Service Information Bulletin

SUBJECT	DATE
Diagnostics	July 2017

Publication Number / Title	Platform	Section Title	Change
DDC-SVC-MAN-0140	DT12 Transmission	SPN 521731/FMI 3	Updates to existing procedures.
		SPN 521731/FMI 4	
		SPN 521731/FMI 5

45801

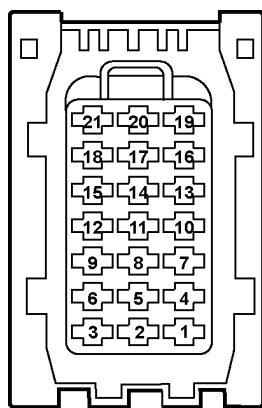
1. Was the Transmission Control Module (TCM) just replaced?
 - a. Yes; remove TCM and inspect all X3 connector mating pins for damage. If damage is found, replace component as necessary. **DO NOT ATTEMPT TO STRAIGHTEN PINS.**
 - b. No; Go to step 2.
2. Disconnect the TCM X1 21-pin connector.
3. Turn the ignition ON (key ON, engine OFF).

4. Measure the voltage between pins 1, 2, 3, 4, and 6 of the TCM X1 21-pin connector (ignition/battery voltage) and ground. Is voltage less than 11.5 volts?
 - a. Yes; restore voltage to pins 1, 2, 3, 4, and 6 of the TCM X1 21-pin connector.
 - b. No; Go to step 5.
5. Turn the ignition OFF.
6. Measure the resistance between pins 16, 19, 20, 21 of the TCM X1 21-pin connector and the negative battery post. Is resistance greater than three ohms?
 - a. Yes; restore battery ground to pins 16, 19, 20 and 21 of the TCM X1 21-pin connector.
 - b. No; Go to step 7.
7. Are any AMT Solenoid faults (SPNs 521736 through 521752 FMI any) also present (active or inactive)?
 - a. Yes; replace the TCM and the Automated Manual Transmission (AMT) shift control unit. Clear faults after repair.
 - b. No; replace the TCM. Clear faults after repair.
